Proposal of a New UN Regulation on the Installation of Safety-Belts, Restraint Systems, Child Restraint Systems, ISOFIX Child Restraint Systems and i-Size Child Restraint Systems

Proposal for the 01 Series of Amendments

Submitted by the expert from Japan *

Photo of the Buckle Strap Path of the UN Regulation No. 129 Test Bench

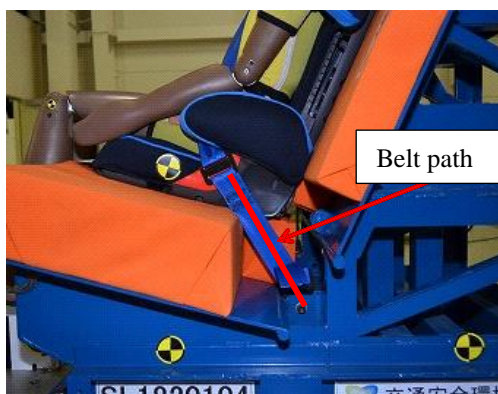
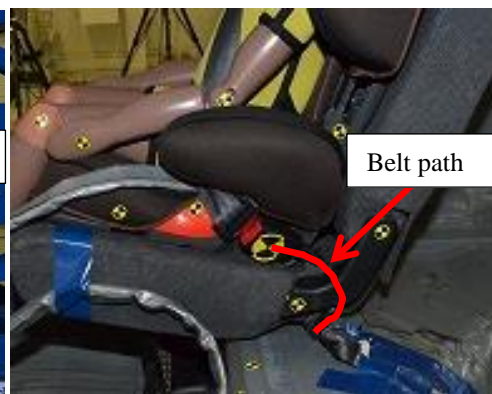
4. The strap's paths between the effective safety-belt anchorage and the buckle are normally straight like the test bench specified in UN Regulation No. 129 (figure 1). However, the strap's paths between the effective belt-anchorage and the buckle of some vehicles in the market are not straight and are curved along the cushion (figure 2).

- 5.2.3.1. The difference between the actual strap length and the straight-line distance between the point EA and Bd point shall be 80 mm or less.
- The above requirements may be shown by the actual vehicle, parts, drawings, or 3D data at the manufacturer's discretion.

Photo of the Buckle Strap Path When Not Straight

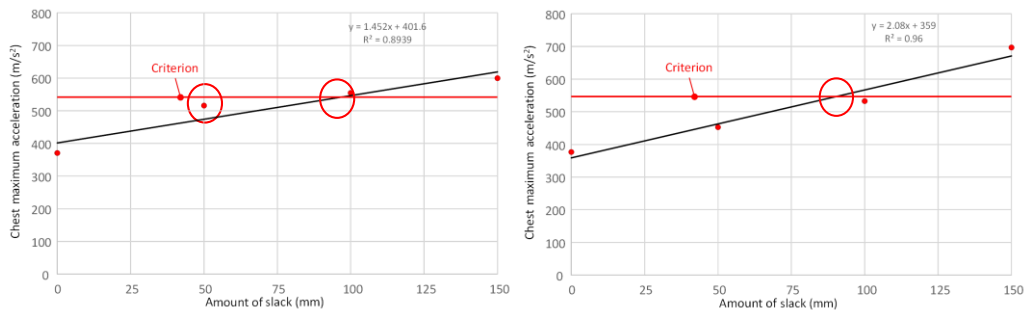
5. When the strap's paths between the effective belt anchorage and the buckle are not straight, the occupants can be thrown forward significantly in a frontal impact accident. If an occupant is seated in the booster seat attached by ISOFIX, there are cases where the seatbelt will slip up to the neck and submarining will occur (referred to in GRSP-69-24). This would increase the risk of injury to the neck and abdomen of a child occupant. In addition, the chest injury of the dummy increases. Figure 3 shows the relationship between the amount of slack in the buckle strap and the maximum 3 ms dummy chest acceleration for two types of Child Restraint Systems. When the buckle slack was 50 mm (see the left graph of figure 3), the maximum chest acceleration in one Child Restraint System approached the criteria of UN
